Extracts for Proposal for a new UN GTR on In-vehicle Battery Durability for Heavy Duty Electrified Vehicles

2024-08-19

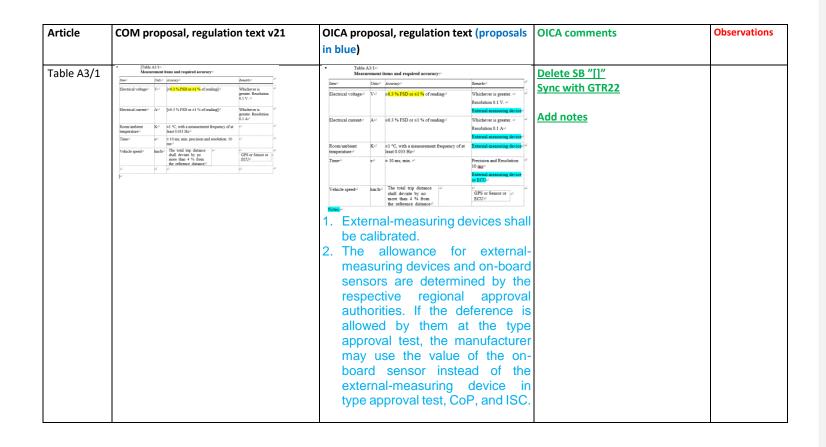
Article	COM proposal, regulation text v21	OICA proposal, regulation text (proposals in blue)	OICA comments	Observations
6.5.1. Verrificatio procedure	required if the manufacturer is requesting to apply the equivalent virtual distance option. In order to verify the virtual distance/En-throughput read from the vehicle, a test shall be performed with adequate and representative use of the	throughput counter is only required if the manufacturer is requesting to apply the energy throughput option. In order to verify the energy throughput read from the vehicle In order to verify the energy throughput read from the vehicle, the energy throughput to be verified shall be calculated using UBE _{certified} in each applicable Table in Annex 4 and verified against the energy throughput read from the vehicleshall be agreed and approved by the responsible authority.	Don't use virtual distance

Article	COM proposal, regulation text v21	OICA proposal, regulation text (proposals in blue)	OICA comments	Observations		
Table 4	All	Delete	Don't use virtual distance			
Step1-4
